From: Webster, Gary [REDACTED]
Sent: 15 May 2020 15:22
To: Jones, Julian D; Maria Tomalova
Cc: Gateley, Jon
Subject: RE: BN/18/20/PL, Former Brooks Nursery
Attachments: 4482-506(D) S104 Layout Phase 2.pdf; 4482-510A Foul Outfall Rising Main Details.pdf; 4482.502E Phase 1 Section 104 layout.pdf

From: Jones, Julian D [REDACTED]
Sent: 15 May 2020 14:59
To: Maria Tomalova <Maria.Tomalova@arun.gov.uk>
Cc: Webster, Gary [REDACTED] Gateley, Jon [REDACTED]
Subject: BN/18/20/PL, Former Brooks Nursery

Project Brooks Nursery Barnham

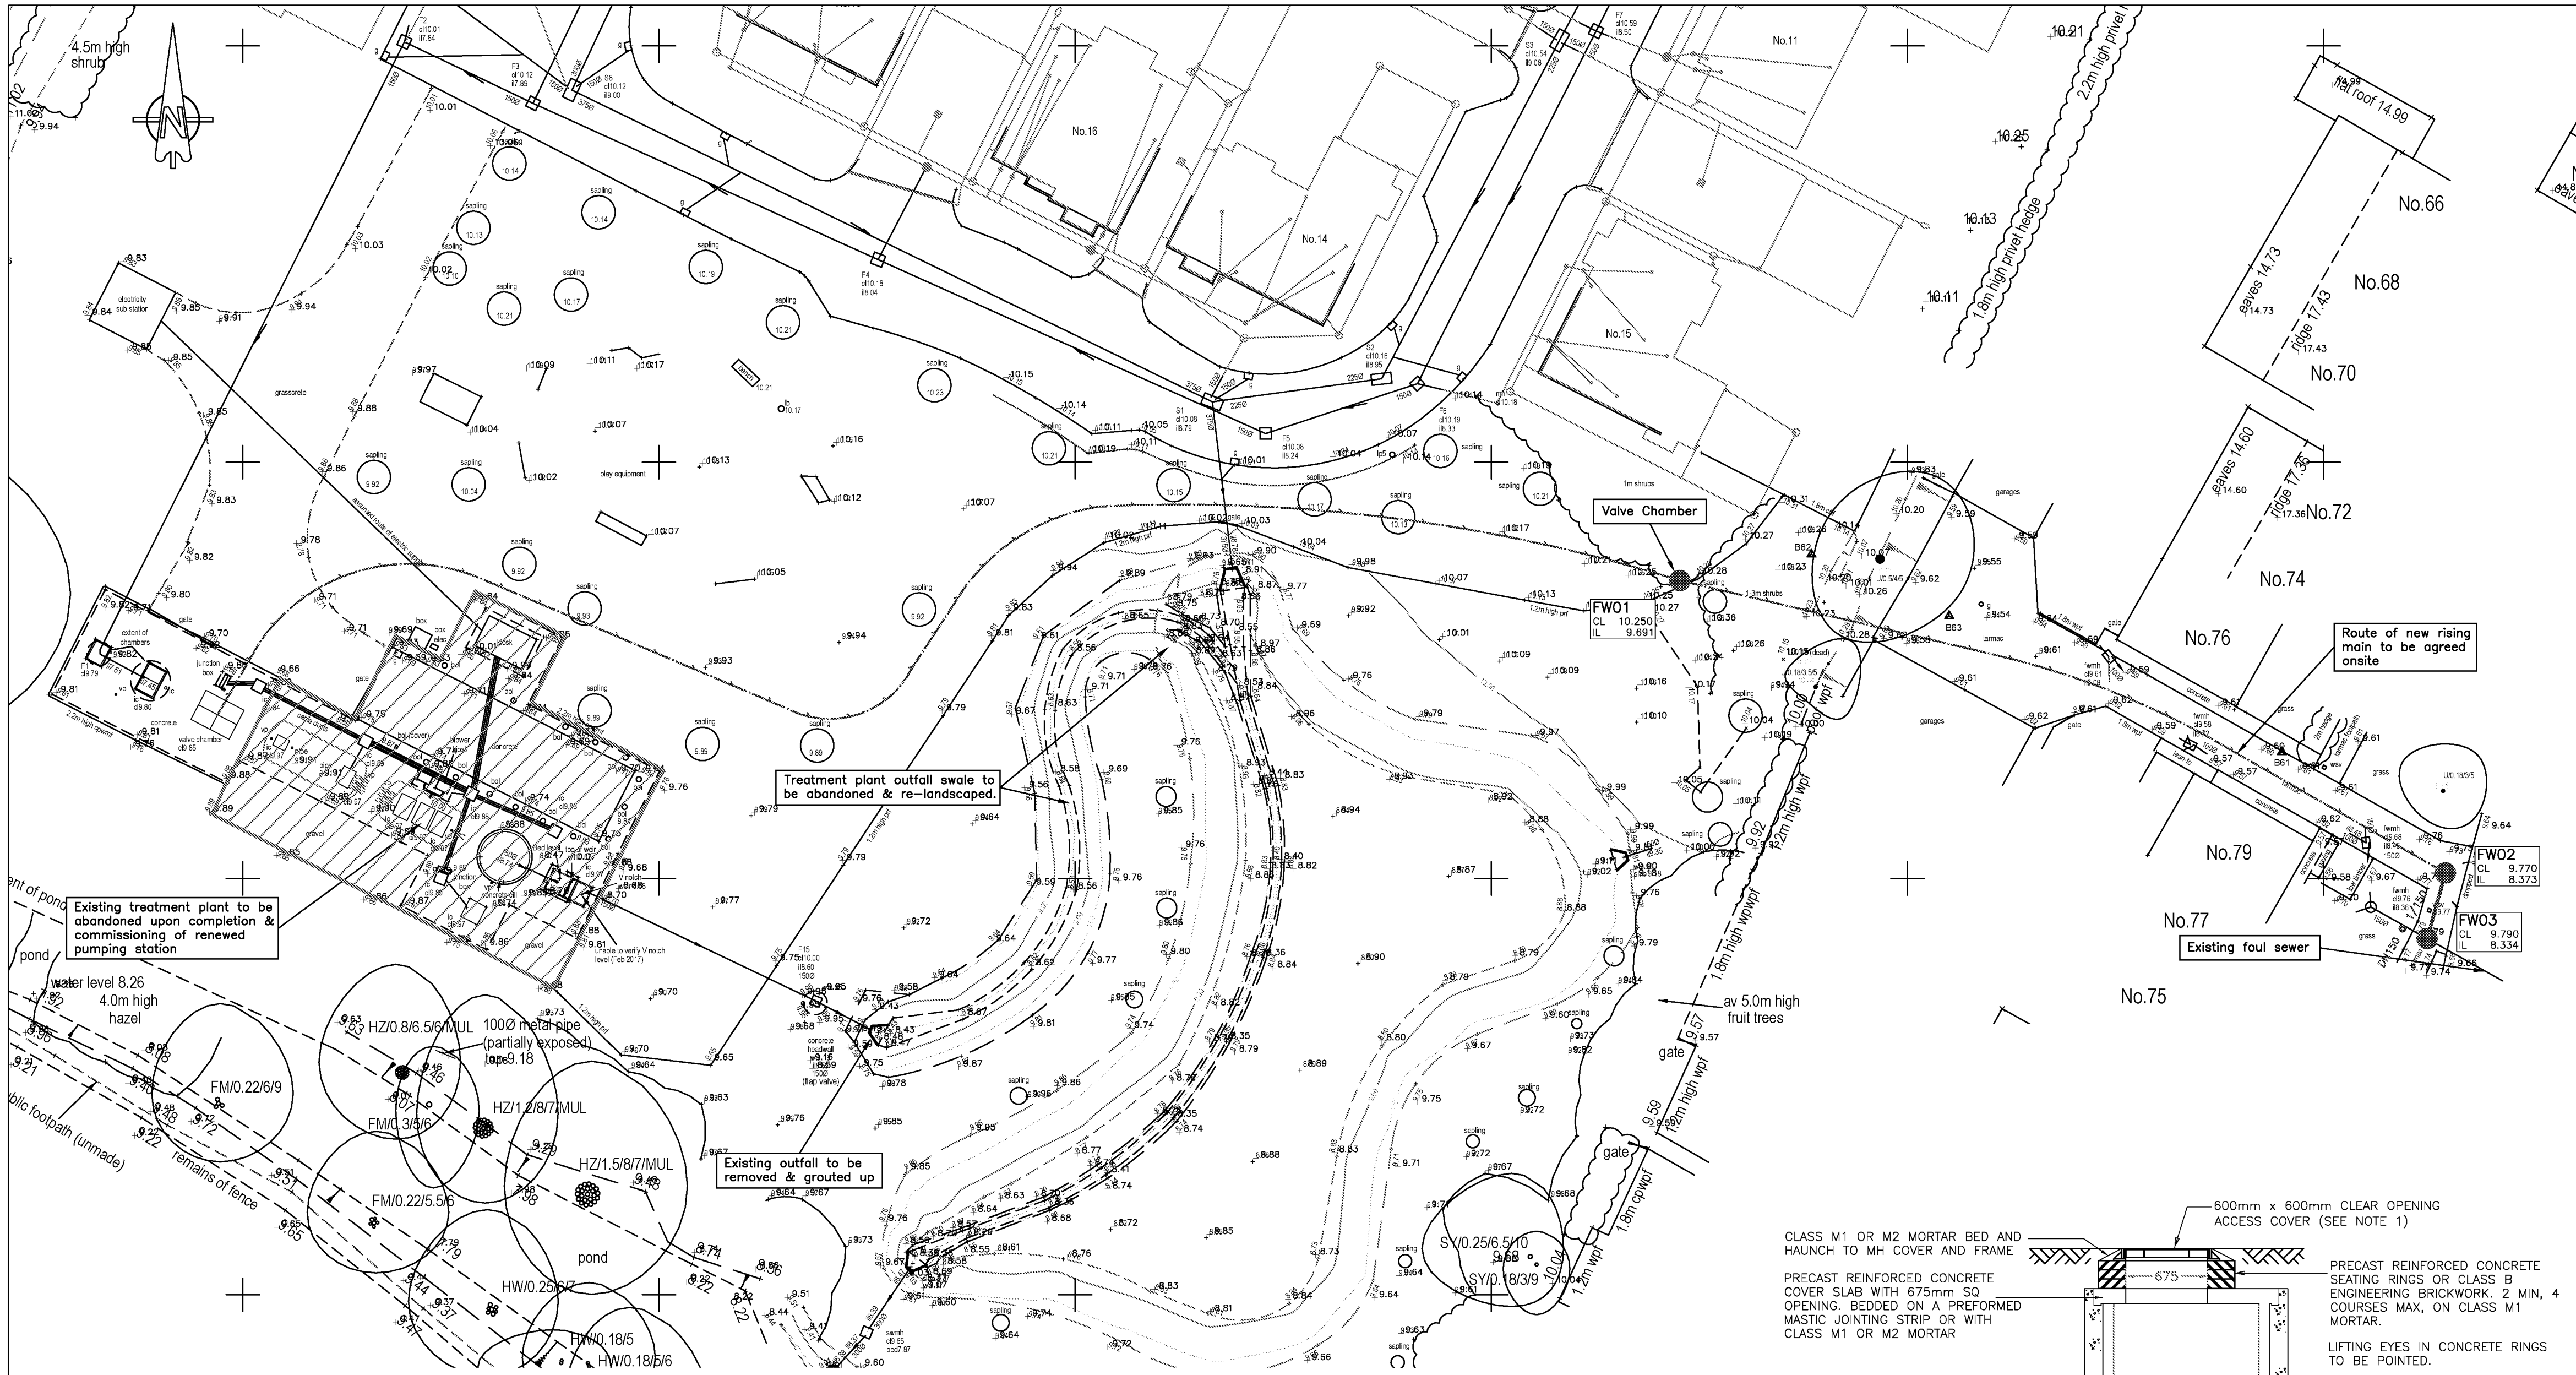
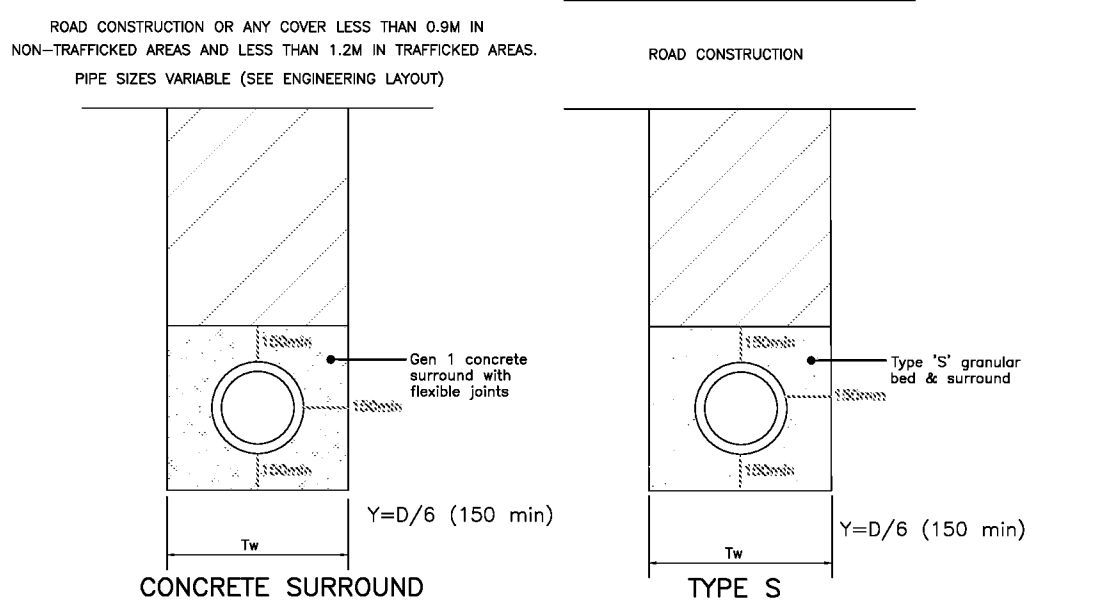
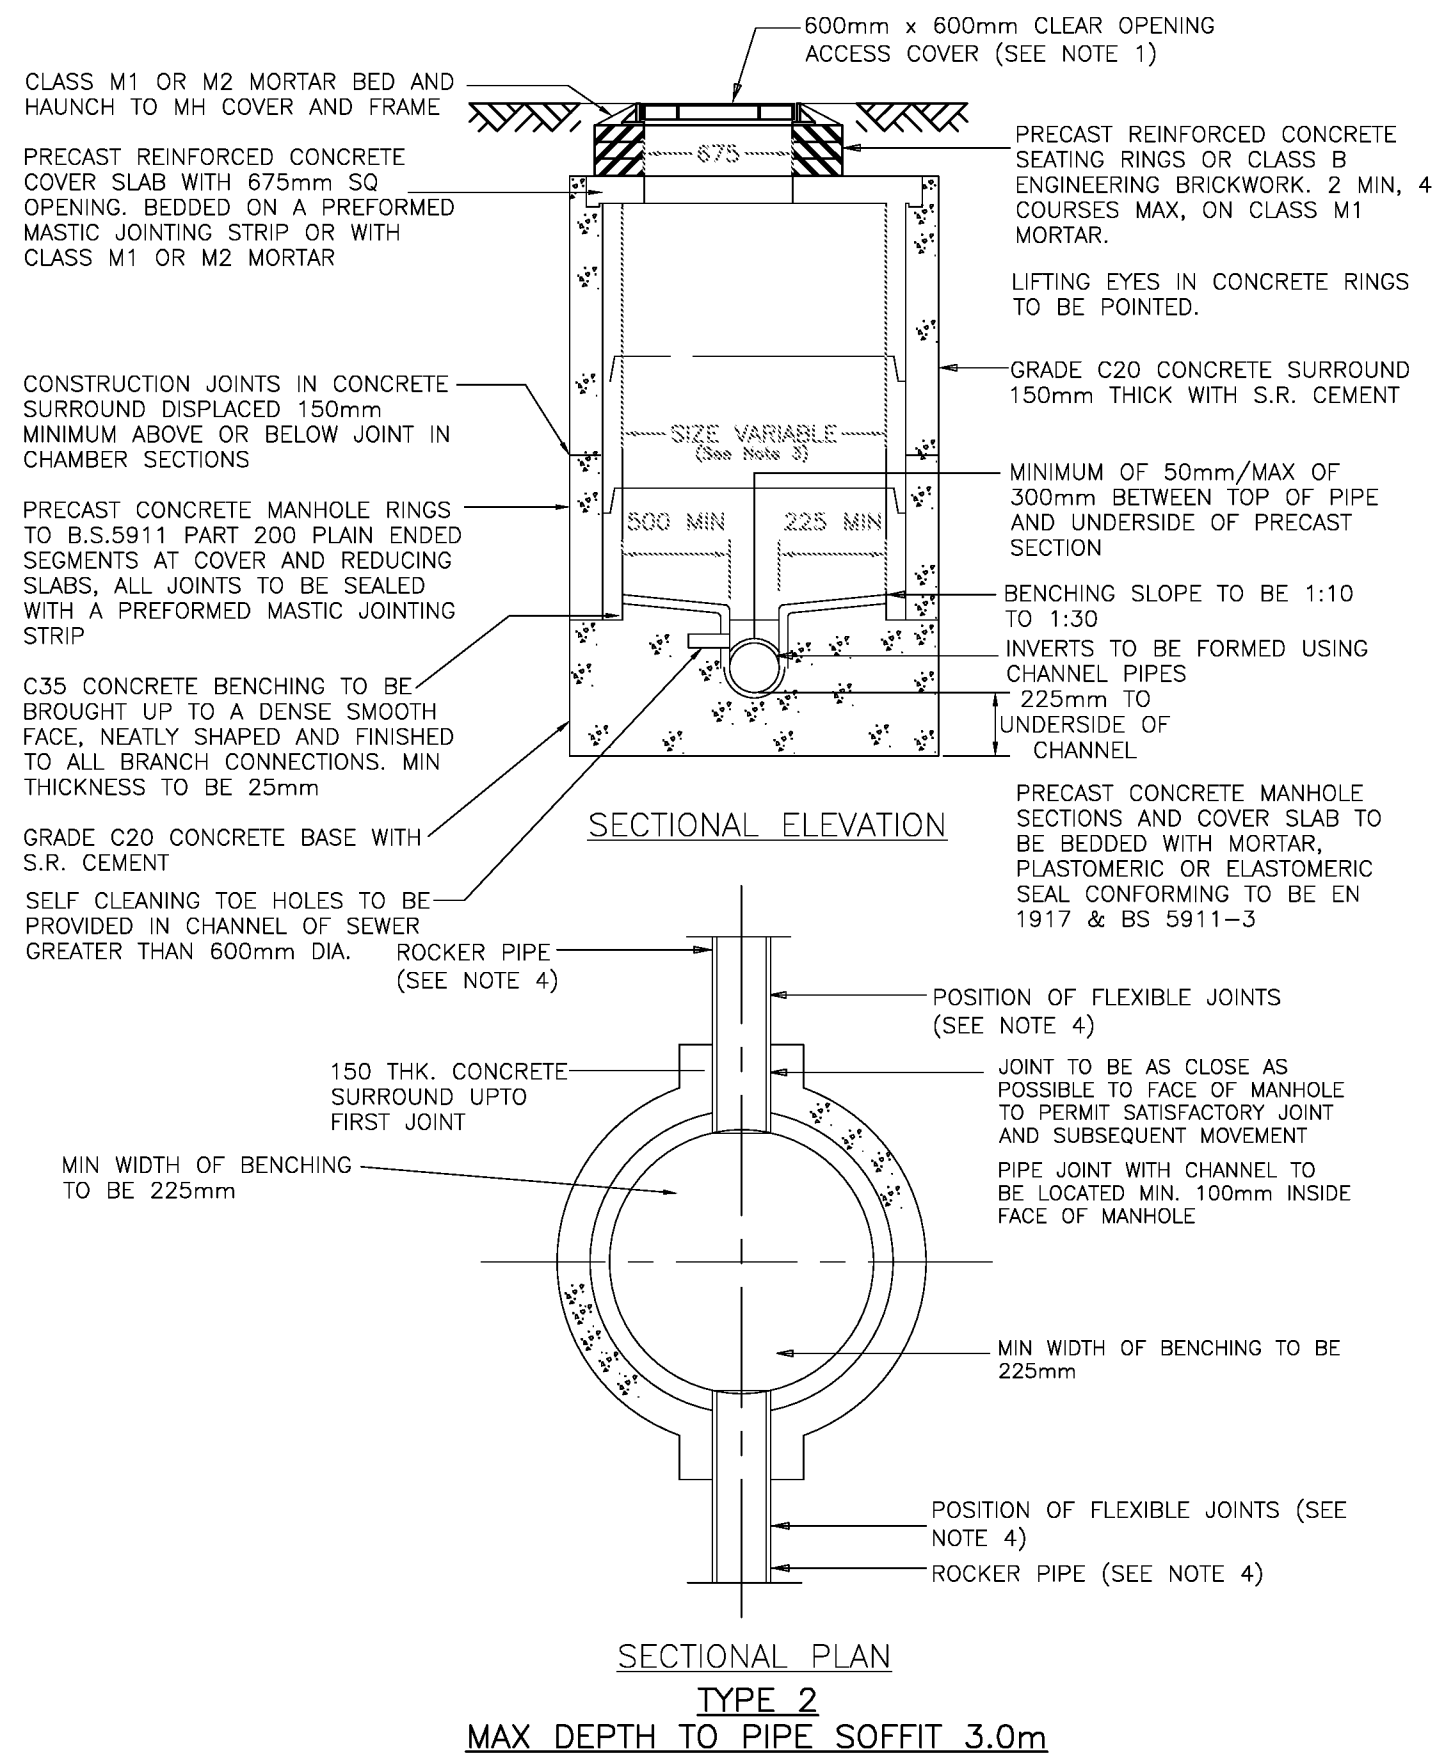
- a) The open channel/ditch in which the sewage treatment plant discharges into at present, before it connects into the suds pond, is proposed to be infilled.
The applicant will need to provide written confirmation with supporting calculations to prove that the storage for surface water within the suds system is not compromised as a result.
- b) Where the proposed rising crosses the incoming surface water outfall to the pond and the known land drain running parallel to the eastern boundary of the development, the applicant should provide a longitudinal section to prove no impact on these pipelines.

Finally, the long section requested was already shown on drawing no, 4482.510A , which I attach for reference along with the other engineers drawings which were agreed at the meeting
